National Fire Protection Association

MEMORANDUM

TO: Technical Committee on Testing and Maintenance of
Fire Alarm and Signaling Systems

SUBJECT: NFPA72 (SIG-TMS) ROP TC Letter Ballot (A2012)

Figure 14.6.2.4

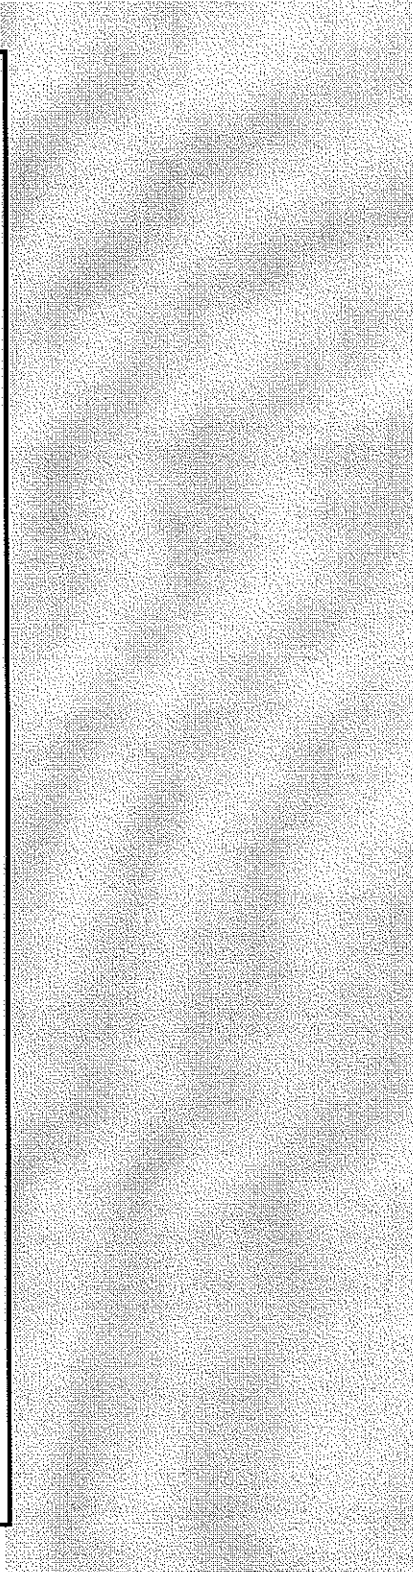
Recommendation: Revise Figure 14.6.2.4 in both figure locations 7.3 and 7.5 and associated A.14.6.2.4 example in both test form locations 7.3 and 7.5
